NORTHERN GOLDFIELDS INTERCONNECT PIPELINE EPA ENVIRONMENTAL REFERRAL

Additional Information

Document No		20199-RP-HSE-0004			
Rev	Date	Status	Originated	Checked	Approved
1.0	30/04/2021	Issued for Use	gmc.		
			-	S. van Straaten	R. Kallath
			(CDM Smith)	Manager Access and Approvals: West	Project Manager
0.1	03/03/2021	Issued for Review	gmc.		
			-	S. van Straaten	R. Cherney
			(CDM Smith)	Manager Access and Approvals: West	Project Manager

Figure 3-1: Carnaby's Black Cockatoo Records and Range

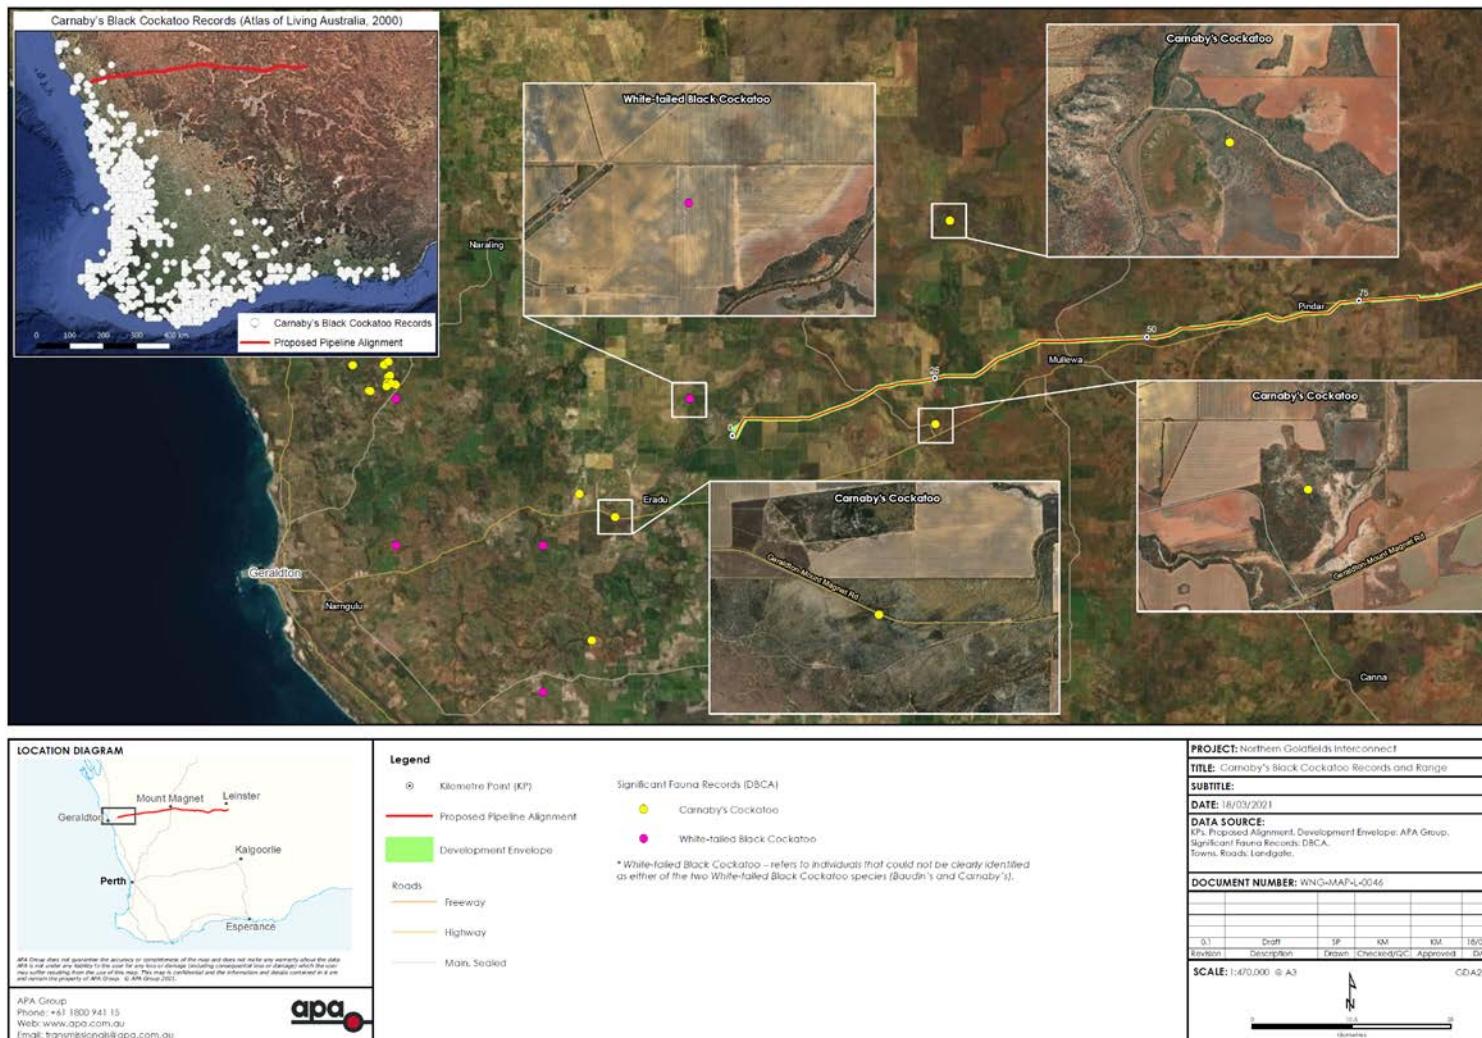
- The referral document states that there will be minimal impact to Carnaby's Cockatoo habitat from the proposal. The EPA notes that the Eucalypt Woodlands of the Western Australian Wheatbelt and Banksia shrublands within the western portion of the development envelope provide suitable habitat for Carnaby's Cockatoo. Please provide further consideration of impacts to this species, to assist EPA in understanding the amount of habitat to be impacted and the potential significant residual impacts to this species.
- Please provide an adequate assessment regarding the significant residual impacts to fauna habitat from the proposal, particularly habitat for conservation significant fauna species, to determine whether offsets are required.

The Carnaby's Black Cockatoo (Endangered, *Environment Protection and Biodiversity Conservation Act 1999* [EPBC Act] and *Biodiversity Conservation Act 2016* [BC Act]) is likely to pass through and occasionally forage in the area. The closest reported records of the species to the Proposal are at Tenindewa (approximately 17 km west of Mullewa, and 7 km south of the Proposal) and from north of Mullewa at Nunierra (Kingfisher, 2020) (**Figure 3-1**). The Carnaby's Black Cockatoo ranges across a large portion of south-western Western Australia, from Kalbarri to Cape Arid (Johnstone and Storr 1998, cited in Kingfisher, 2020) (**Figure 3-1**). While the species range lies mostly west of the Proposal, the portion of the development envelope between Ambania to near Mullewa occurs within the species predicted range (Kingfisher, 2020). However, due to pre-existing widespread clearing for agriculture, there is limited breeding and foraging present in the development envelope (Kingfisher, 2020).

Figure 7-1: Mapping of Calcrete Groundwater Assemblage PECs

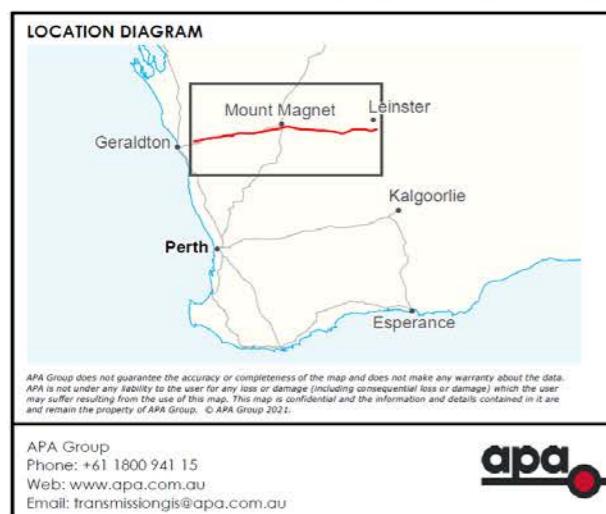
The EPA notes that the proposed pipeline will intersect five calcrete priority ecological communities (PECs), which have the potential to support locally endemic subterranean fauna communities. Please provide information that demonstrates that suitable habitat for subterranean fauna does not occur in the proposed development envelope, as stated in your referral document. Where there is suitable habitat please identify the potential impacts of the implementation of the proposal on the subterranean fauna communities within these PECs and, where relevant and appropriate, the avoidance and mitigation measures for any potential indirect impacts.

The mapped locations of the above PECs, relative to the Proposal linear alignment, are shown in **Figure 7-1**.

Since the time of referral, the project team has progressed the definition of areas of HDD works, which represent the deepest point of excavation relevant to the Proposal. It is confirmed that these areas of HDD works do not occur in or directly adjacent to any of the PECs as shown in **Figure 7-1**.
